Product Change Notification (PCN)

PCN Number	508845	Date Issued	September 01, 2020
Reason for Change	Change to Product		
Change Type Description	<p>This letter is to inform you that changes are being made to the part(s) identified in this Notice. The change may affect the fit, form, function or appearance of the parts, or it may result in a change to the specification. The pictures below show an example of the possible differences.</p>		
Reason for Short Notice	Corrective Actions		
Assessment of Change	Dimension analysis		
Internal Molex Qualification Date	May 08, 2020		
Sample Availability Date (Changed Part)	May 08, 2020		
Planned Implementation Date	September 01, 2020		
Method of Identifying Change	Factory order number

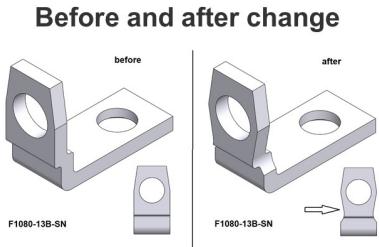
- We are changing the sub-product element form in order to meet our product conformance;
 - A sub-product element known as a metal angle plate is getting changed. This metal angle plate was sticking to the hoods of the connector and was getting pressed in the current design. This is undesirable. Cutouts for reverse use are added. Change of the outer geometry to enable reverse application in the connector is also enabled.
- Product Impact
 - There is impact to form/ appearance of the product
 - No impact on Function and Fit
- Part Number Impact
 - See attached impacted parts list
- Qualification Reports and samples available upon request after the date shown above
